Application for Licence Amendment

Licence Number	L8457/2010/2
Licence Holder	Silver Lake (Integra) Pty Limited
ACN	093 278 436
File Number	2012/006865
Premises	Salt Creek Processing Facility Mount Monger Road EMU FLAT WA 6431 Legal description – Mining Tenements M25/71, M25/125, M25/133, M25/307, M25/347 General Purpose Lease L25/27, L25/29, L25/31, L25/33, L25/41 Miscellaneous Licence G25/02 As defined by the Premises maps attached to the Revised Licence.
Date of Report	1 August 2024
Decision	Revised licence granted

Figure 1: Standing water level around TSF2

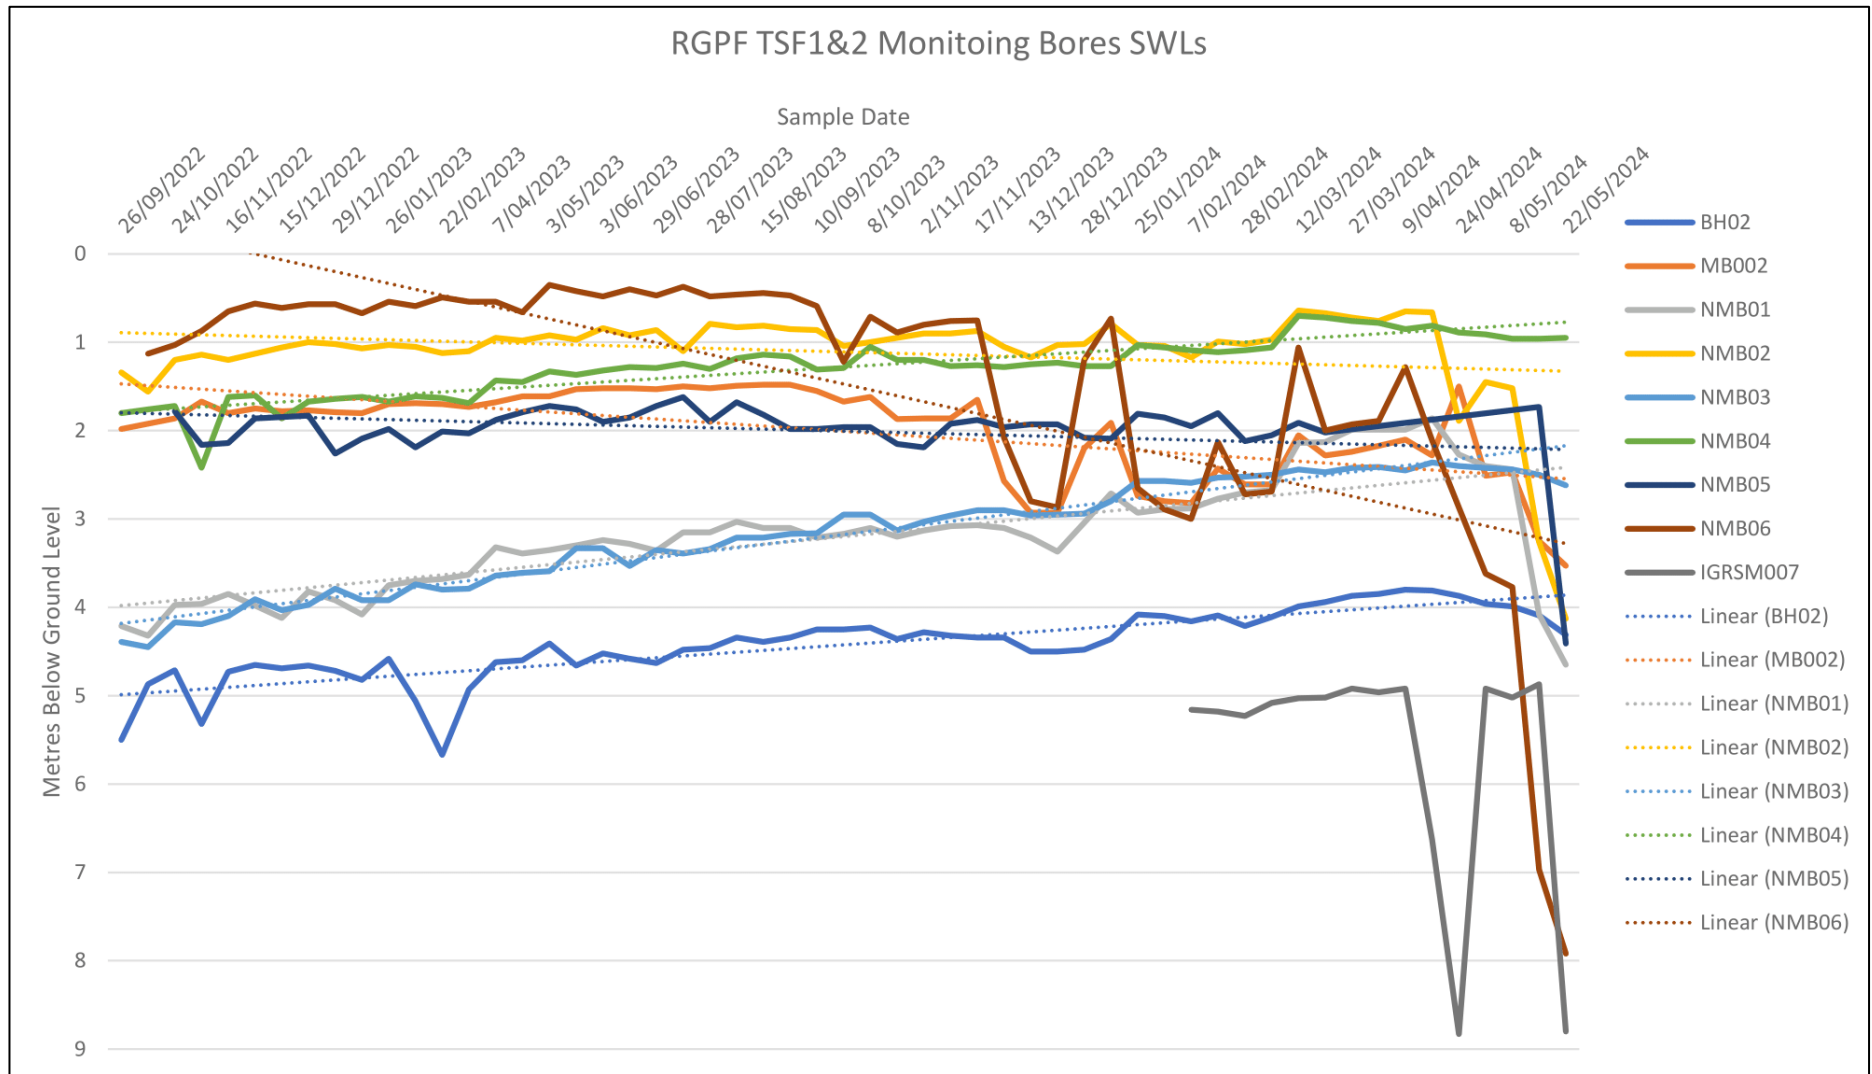
In April 2024, the Licence Holder began observing a decline in SWL at several monitoring bores (Figure 1). This indicates that tailings and groundwater management at TSF2 may be having a positive impact on the groundwater mounding issues.
